CSSI 7474 Narrabri to North Star, Phase 1 (N2NS Project)
Transport Network and Connectivity Analysis (Jones Avenue Overbridge)
RFI-25882898 Transport Network and Connectivity Analysis

Project	CSSI 7474 Inland Rail – Narrabri to North Star, Phase 1 (N2NS)
Document	Transport Network and Connectivity Analysis
Date received from ARTC	4.8.21
Date comments sent to ARTC	11.8.21

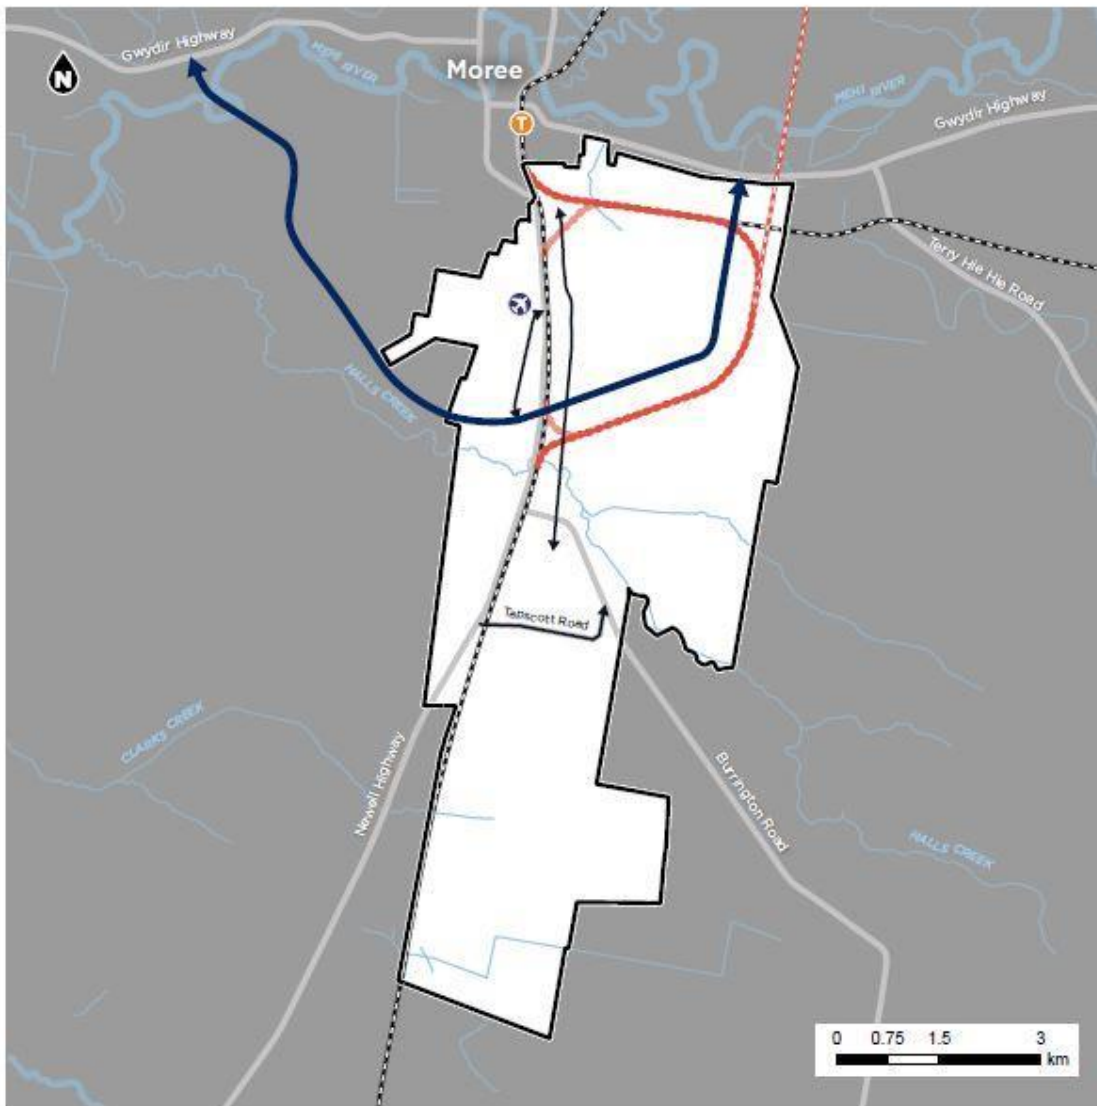
2	E57(d)	community safety and severance impact of formal or informal changes to heavy vehicle routes;	From the reference documents you note in Table 1 of the analysis, it is difficult to determine how community safety and severance impact has been considered. DPIE Comment 2.1: Please provide a clearer indication of how this part of the condition has been met in the analysis.	Background Information The online Restricted Access Vehicle maps for Moree provide information on the enforceable road network restrictions and routes available for use by heavy vehicles in Moree. The Gwydir Highway, to the west of Moree, forms a key freight link between Perth/Adelaide and Brisbane. The Gwydir Highway is the only B-Double route between the North East – North West Region and the NSW North Coast (refer to Section 4.5.1.2.2 of the Transport Plan). Historically, heavy vehicles using the Gwydir Highway, coming from west of Moree and needing to travel south on the Newell Highway to Narrabri have used the old Newell Highway route through Moree. A restricted access route for heavy vehicles through Moree was established using Greenbah Road, Heber Street, Edward Street and Jones Avenue to access the Newell Highway. Since the completion of the Moree Bypass in 2013, the Gwydir Highway has been re-routed to run along Greenbah Road, then onto Coolbah, Gwydir and Balo Streets, before heading north over the Mahaffey Bridge at Broadwater Creek onto Boggabilla Road and joining the Newell Highway south. Both routes continue to be used by heavy vehicles. Response MPSC's transport program (referred to in ARTC's correspondence to DPIE of 3 August 2021) was reviewed as part of the Moree SAP transport investigations (refer to Section 7.1.5 of the Transport Plan). This program considered the safety and severance issues associated with heavy vehicles using the old Newell Highway route, utilising Jones Avenue.

Jones Avenue is located in a highly urbanised area of Moree. (See attached Map 1.) The area is characterised by heavy foot traffic as compared to other areas of Moree given the proximity to schools and demographics of those who live in that area of Moree. The MCA considered social and economic considerations including alignment and integration with MPSC's future town planning, severance impacts and residential impact/ proximity to sensitive areas. If the Jones Avenue Overpass was to proceed, heavy vehicles would enter east Moree residential areas around Dingwall Place. The preferred MIO location means that heavy vehicles will follow existing formal transport routes (detailed in the Background Information above) before joining the Newell Highway and using the MIO to access existing intermodal sites, industrial area and future Activation Precinct. With the preferred location of the MIO now to the south of the Moree township, the community severance and safety issues that would have been created by the Jones Avenue overbridge no longer exist. Over time, the Airport South MIO, together with the future planned infrastructure of the East-West Connector, will redistribute heavy vehicle movements to outside the residential areas of Moree. Refer to Map 2.
